EA-06-200

SUBJECT: TURKEY POINT NUCLEAR PLANT - NRC INSPECTION REPORT
05000250/2006015; PRELIMINARY WHITE FINDING

IR 05000250/2006-015; 08/06/2006 - 08/17/2006; Turkey Point Nuclear Power Plant, Unit 3; Other Activities.

~~ATTACHMENT 2 - OFFICIAL USE ONLY - SECURITY-RELATED INFORMATION~~Turkey Point
3A 4160 Volt Bus (Simplified)

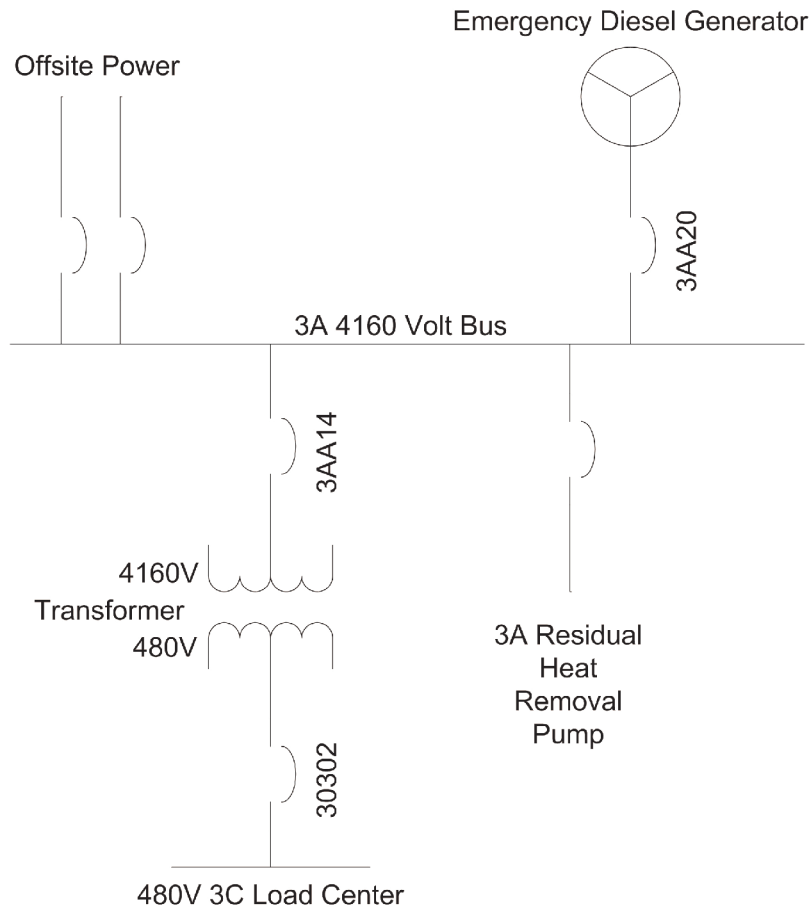
Description: On March 8, 2006, following the early completion of electrical bus maintenance, the licensee initiated an electrical restoration to the 3C 480 volt load center from the A 4160 volt safety bus (See figure below).

The 480 volt supply breaker to the 3C Load Center (breaker 30302) had been replaced (like for like) with a refurbished breaker, and unknown to the operators, the auxiliary switch of the breaker was installed such that the breaker open contact was "off" with the breaker shut and "on" with the breaker open, while the opposite was desired. The auxiliary contact made up logic for the 3A bus sequencer which used 3C load center

voltage and breaker (30302) position as an indication of proper electrical status of the safety busses. After breaker 30302 was installed (in the open position), the operator shut 4160 volt breaker 3AA14, "3C Load Center Feed from 3A 4160 Volt Bus" (See Figure). The 3C Load Center remained de-energized, as intended, but because of the reversed auxiliary contacts, the lineup made up sequencer logic that the 3C load center power supply breakers were both shut (while breaker 30302 remained open) and the load center had no voltage, which initiated a sequencer load shed of the 3A 4160 volt bus. The load shed stopped the running A RHR pump, which resulted in a loss of decay heat removal. The sequencer started the 3A emergency diesel generator and re-energized the bus. As expected the A train intake cooling water pump and A train component cooling water pump (both part of the decay heat removal train) were sequenced on. The RHR pump was not restarted and operators entered 3-ONOP-004.12, "Loss of 3A 4KV Bus While on Backfeed", which assured proper electrical sequencing. Had proper sequencing not taken place, the procedure would have directed actions to restore power to the 3A bus. Because the sequencer had worked properly, 3-ONOP-004.12 directed transition to 3-ONOP-004.10, "Loss of Offsite Power While on Backfeed", which assured proper starting and loading of the diesel generator. Because decay heat removal had stopped, 3-ONOP-004.10 directed the operators to 3-ONOP-050, "Loss of RHR", which was used to restore decay heat removal. During the loss of cooling, the coolant system temperature increased from an estimated 113 degrees F to 140 degrees F.

The loss of shutdown cooling could have been prevented by any one of the following risk management actions: 1) The 3B RHR pump could have been started prior to the switching evolution to provide core cooling while performing the restoration activities on the A 4160 volt to 480 volt load center; 2) The 3A sequencer could have been disabled to prevent load shed should a sequencing or other problem with the restoration operations occur; and 3) The 480 volt breaker being installed could have been appropriately tested or inspected prior to placing the breaker in service to detect the improper auxiliary switch status.
